REMARKS

This case has been carefully reviewed and analyzed in view of the Official Action dated February 9, 2005.

FIG. 4

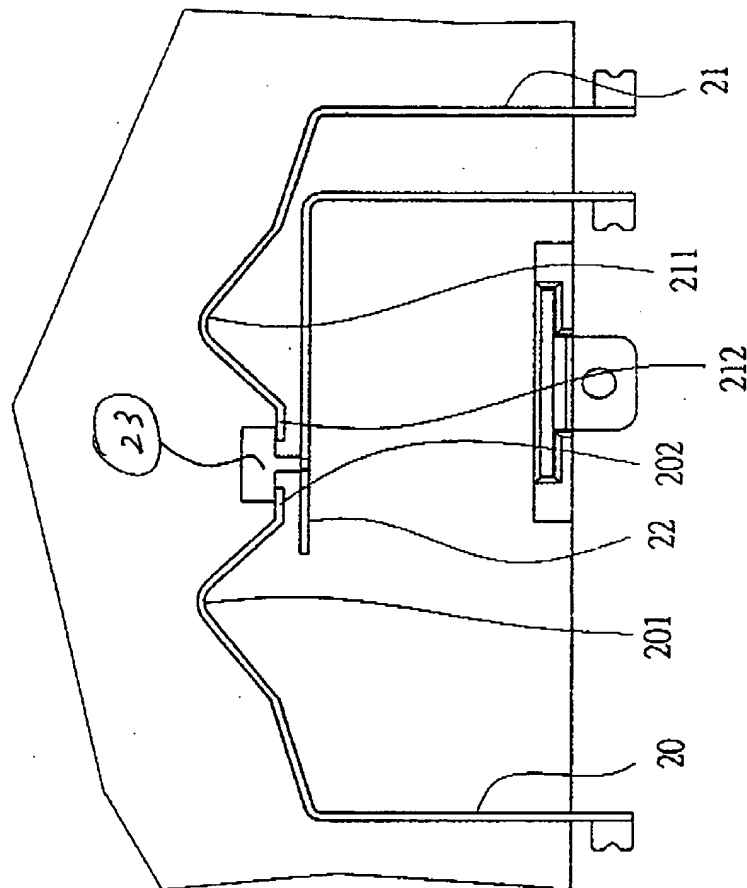
The Examiner has objected to the drawings because they do not include reference sign(s) mentioned in the description. Further, the Examiner has objected to the drawings under 37 CFR 1.83(a). Replacement sheets of the drawings for FIGS. 4 and 7 are submitted for the Examiner's approval and the specification has been amended to overcome the objections.
